SAMMITR (Australia) Pty Ltd

SMM Technical Bulletin		
Bulletin Number:		
Subject:	Rear Door Strut Options	
Date:

We are pleased to announce the release of rear door struts options for the V2 Canopy.

STANDARD	OPTION 1	OPTION 2
PRODUCT CODE	2010707464SA	2010707464SA-M	201070746SA-S
Size	430mm	410mm	390mm
Rear Door Canopy Edge	80cm (Standard)	74cm (-6cm)	66cm (-14cm)

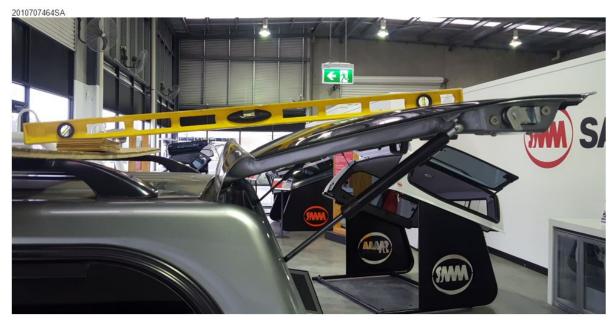
Rear door strut options are shorter in length which allows a reduction in the height of the rear door allowing the customer to carry longer items without the rear door impeding.

Please see below examples illustrating the change in height of the rear door with the options available.

(Standard)	(Option)	(Option)
Product code	2010707464SA	2010707464SA-M	2010707464SA-S
Size	430mm	410mm	390mm
Rear door canopy edge	80cm (standard)	74cm (-6cm)	66cm (-14cm)
